MONITORING YEAR 4

MOORES FORK STREAM MITIGATION PROJECT

DMS Project Number 94709

Wildlands Engineering, Inc. (Wildlands) has reviewed the Division of Mitigation Services (DMS) comments from the Draft Monitoring Year 4 report for the Moores Fork Stream Mitigation Project. The following Wildlands responses to DMS's report comments are noted in italics lettering.

Figure 3.2 Integrated Current Condition Plan View (Sheet 2 of 6)
 Moores Fork Stream Mitigation Project
 DMS Project No. 94709
 Monitoring Year 4 - 2019

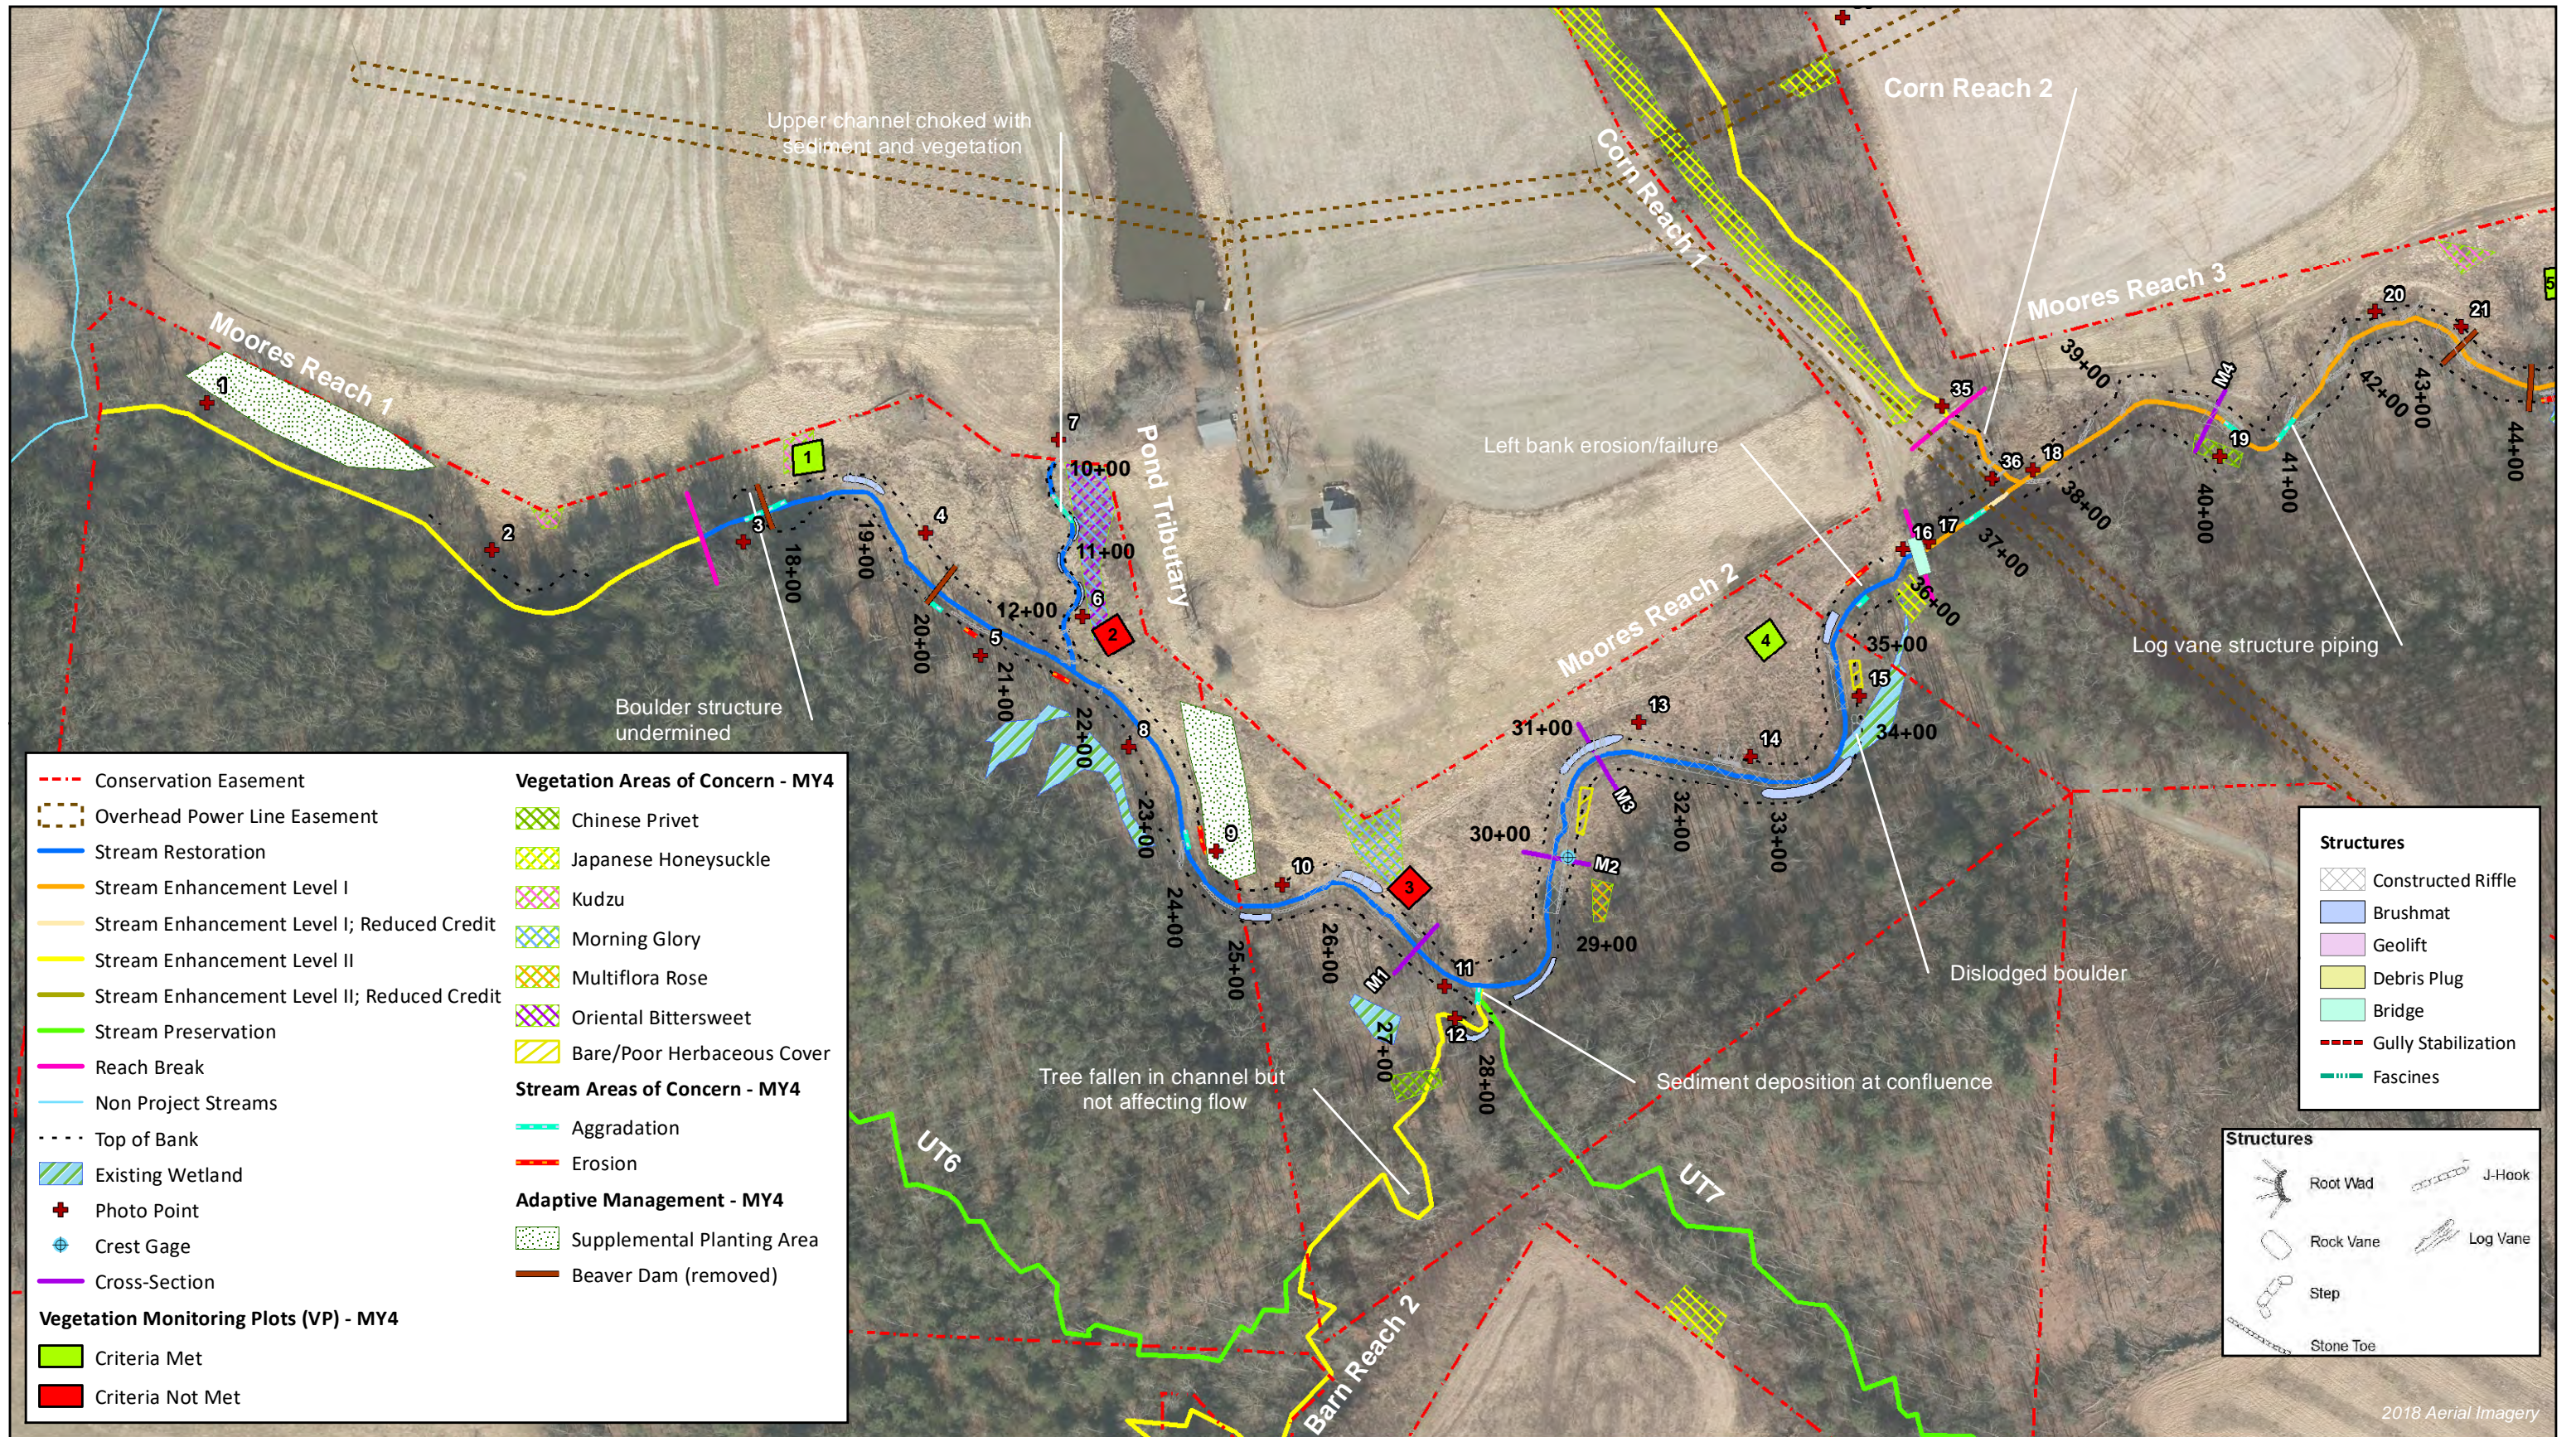
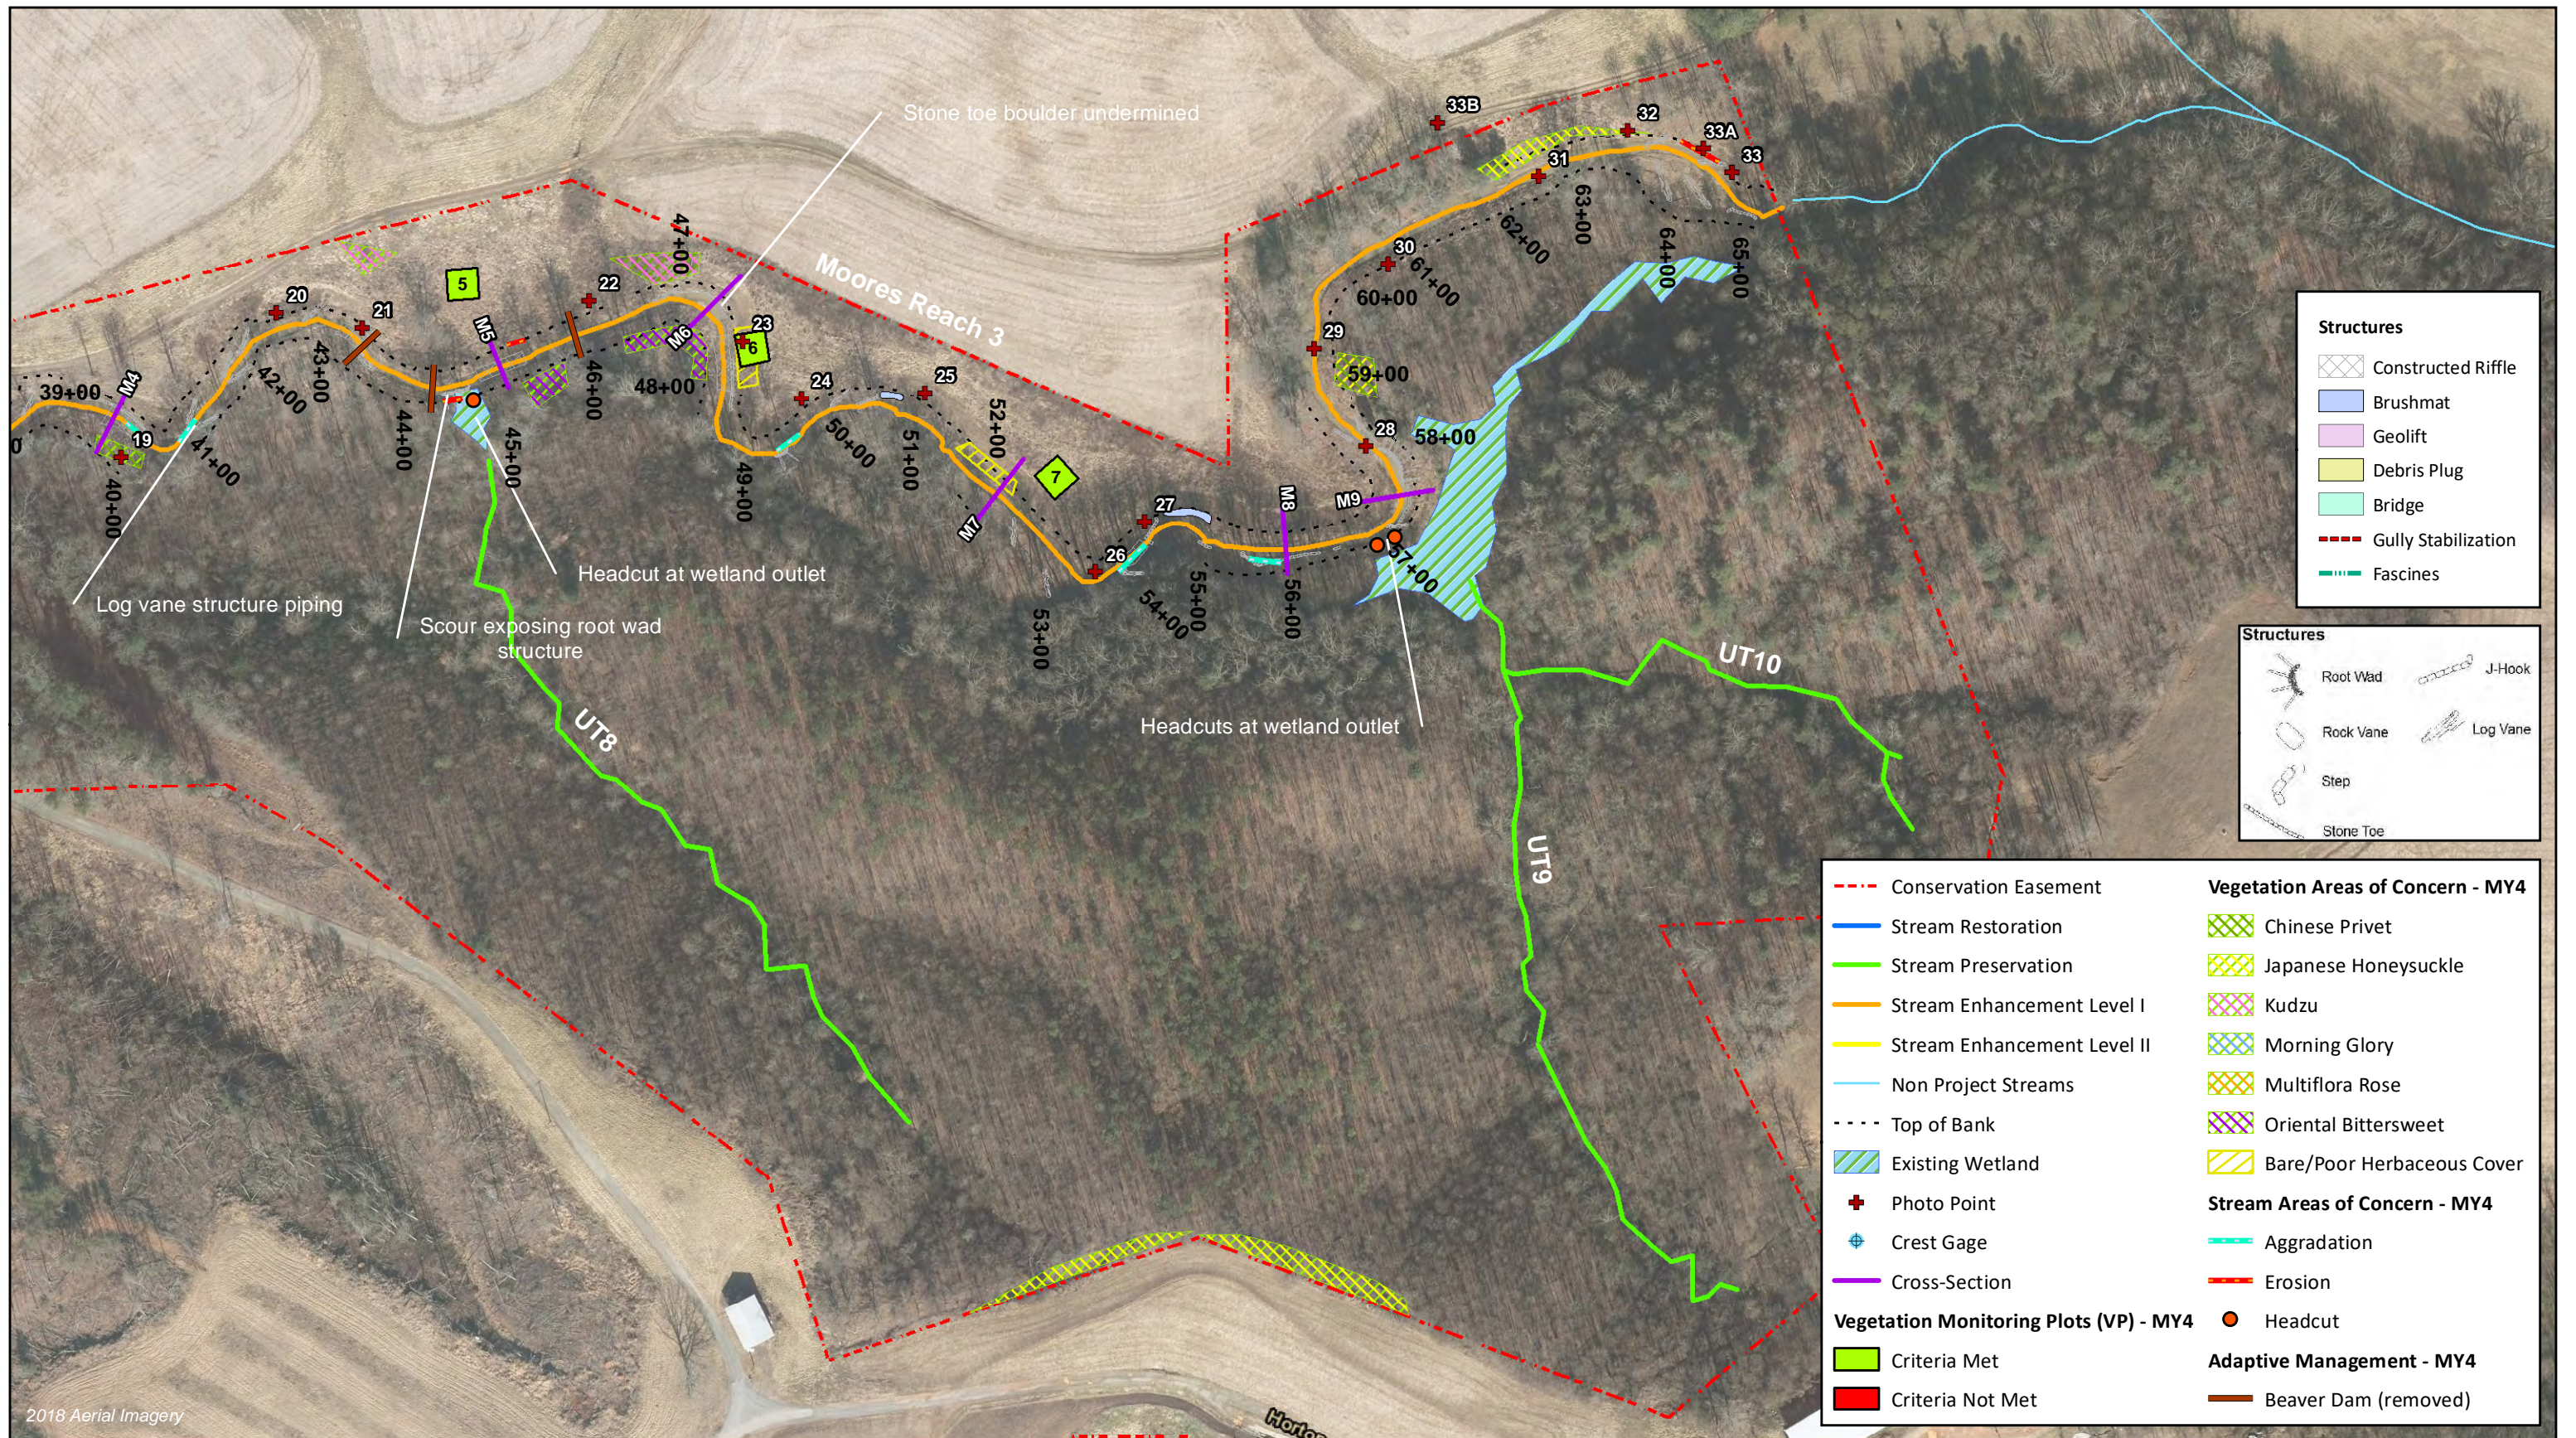
DMS comment; 1.2.2 Vegetation Areas of Concern: The supplemental planting that was completed in March 2019 consisted of 400 bare roots spread across four areas of the site determined to have low stem density based on the MY3 plant warranty inspection report. A pdf of the areas has been included. Please add these areas to the CCPV.

continue to monitor the site for beaver activity through closeout. A map is included with approximate locations of the dams. Please add this to the CCPV.

DMS comment; CCPV: Thanks for providing updated invasive species polygons. Please continue to update as treatment occurs and populations are reduced. This map is a useful tool for the contractor treating the site.

Wildlands response; Text was added to Section 1.2.2 to indicate that 400 bare roots were planted in March 2019. The four areas where supplemental planting took place were added to the CCPV.

Wildlands response; Text was added to Section 1.2.4 to detail the management of beaver activity for the Site in 2019. The approximate locations of the dams were added to the CCPV.

Wildlands response; Wildlands will continue to update the CCPV figures as treatment of invasive species occurs and populations are reduced.
